UNITED STATES
DEPARTMENT OF THE INTERIOR
BUREAU OF LAND MANAGEMENTFORM APPROVED
OMB NO. 1004-0137
Expires: January 31, 2018**SUNDRY NOTICES AND REPORTS ON WELLS**
Do not use this form for proposals to drill or to re-enter an abandoned well. Use form 3160-3 (APD) for such proposals.5. Lease Serial No.
NMNM56749

8. Well Name and No.
TEXACO FEDERAL 29. API Well No.
30-025-3094310. Field and Pool or Exploratory Area
SWD; DELAWARE11. County or Parish, State
LEA CO COUNTY, NM**SUBMIT IN TRIPLICATE - Other instructions on page 2**

~~Abandonment Conditions of Approval~~

Texaco Federal 2 (3002530943), NMNM56749
1980' FNL and 2310' FEL, Sec. 14, T19S-R33E
Lea County, New Mexico

30-025-30943

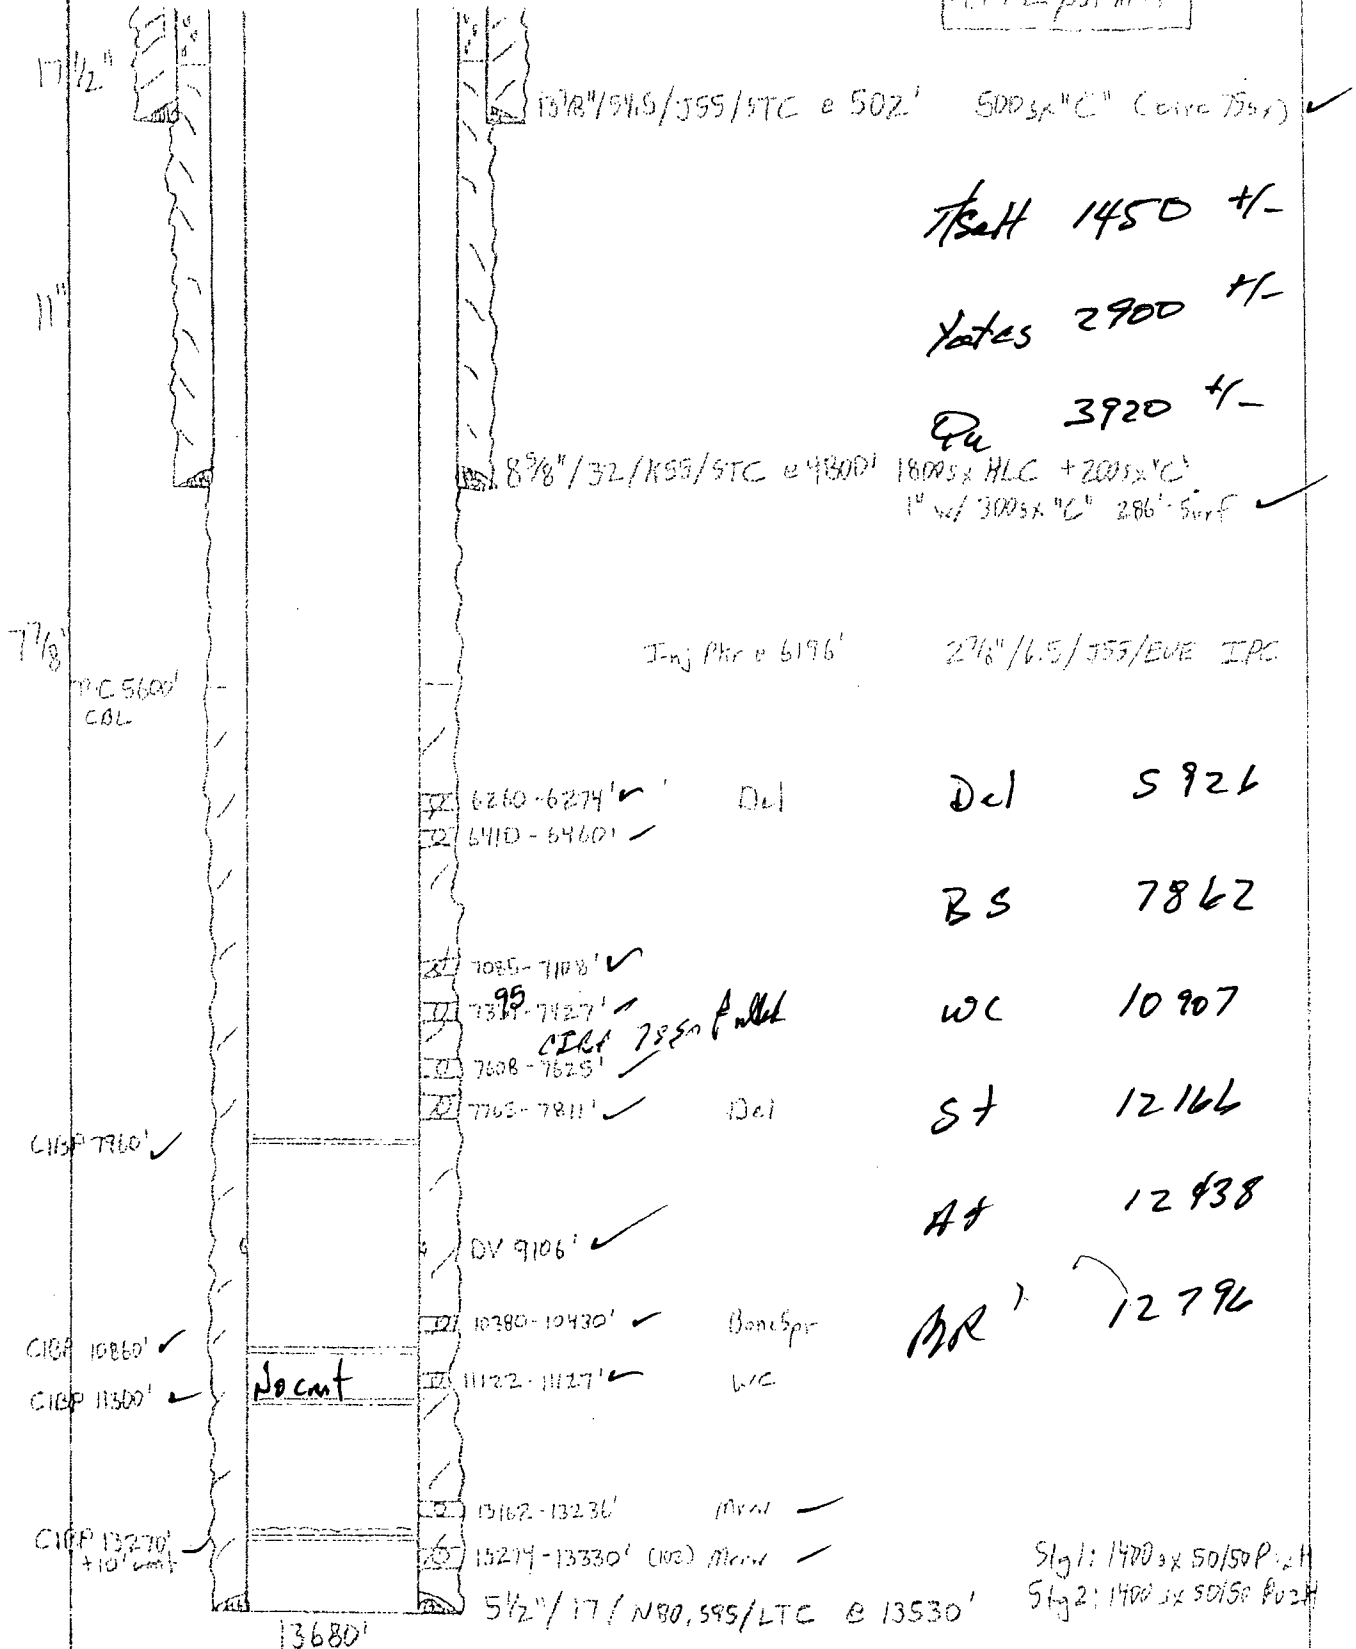
Approval subject to the following changes:

Clean out wellbore to 13270. Set 5-1/2" CIBP @ 13012'. Spot Class H cmt from 13012'-12746 (covers uppermost Morrow perf and top of Morrow formation).

Set 5-1/2" @ 11022'. Spot Class H cmt from 11022'-10822 (covers uppermost Wolfcamp perf and top of Wolfcamp formation).

Spot Class H cmt plug from 9206'-9006'. WOC tag (Covers DVT).

1. Spot Class H cmt plug from 8000'-7812'. WOC tag (covers top of Bone Spring).
2. Set 5-1/2" CIBP @ 6210'. Spot Class C cmt from 6210-5876 (covers uppermost Delaware perf and top of Delaware formation).
3. Okay as is.
4. Okay as is.
5. Perf & sqz 50 sx cmt from 1700'-1500'. WOC tag (top Salt).
6. Okay as is.
7. Okay as is.
